Access Compliance Report

Public Rights-of-Way

(Curb Ramps)

Intersection ID: 10020377	Main Street: BALLANTYNE_CORPORATE_PC	Cross Street: N/A	Location: SE
ADA ID: 38A685111931	Ramp Type: Perp	Initial Pass/Fail: Fail	Overall Compliance: No
Severity Score: 58.75			
Codes/Mitigation Info/Possible Solution		Field Measurements/Component Compliance

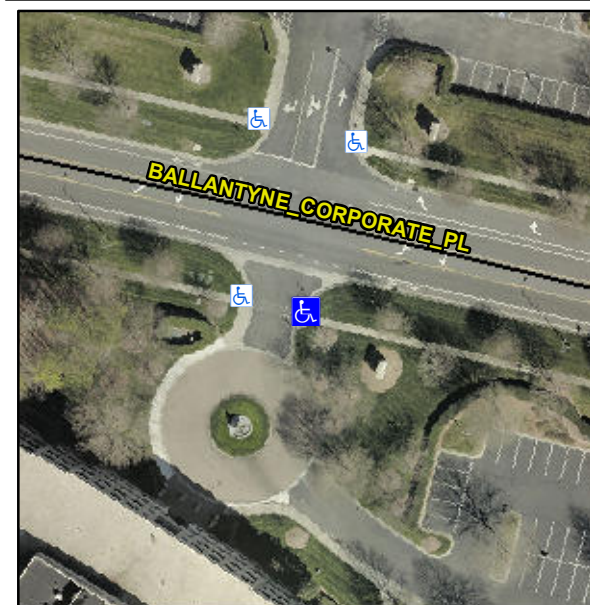
R304.5.1, R304.2.2, R304.5.3

Compliance	Description	Data	Compliance	Description	Data
N/A	Ramp Length (in)	84.0	No	Ramp Slope (%)	13.1
No	Ramp Width (in)	47.0	No	Ramp XSlope (%)	7.6
N/A	Flare Type LT	N/A	N/A	Flare Type RT	N/A
N/A	Flare Slope LT (%)	N/A	N/A	Flare Slope RT (%)	N/A
N/A	Flare Traversable LT?	N/A	N/A	Flare Traversable RT?	N/A
N/A	Landing Length (in)	N/A	N/A	DWS Provided?	N/A
N/A	Landing Width (in)	N/A	N/A	DWS Contrast?	N/A
N/A	Landing Slope (%)	N/A	N/A	DWS Length (in)	N/A
N/A	Landing X Slope (%)	N/A	N/A	DWS Full Width?	N/A
N/A	Landing Curb? (Y/N)	N/A	N/A	DWS Offset (in)	N/A
N/A	Shared Landing?	N/A			
N/A	Gutter Ponding?	N/A	N/A	Gutter Slope (%)	N/A
N/A	Gutter Lip Ht (in)	N/A	N/A	Gutter X Slope (%)	N/A
N/A	Painted X Walk1?	Yes	N/A	Painted X Walk2?	N/A
	X Walk 1 Direction	To NW		X Walk 2 Direction	N/A
N/A	X Walk 1 Width (in)	50.0	N/A	X Walk 2 Width (in)	N/A
	X Walk 1 Slope (%)	7.9		X Walk 2 Slope (%)	N/A
	X Walk 1 X Slope (%)	3.4		X Walk 2 X Slope (%)	N/A

Remove & Replace Entire Ramp.
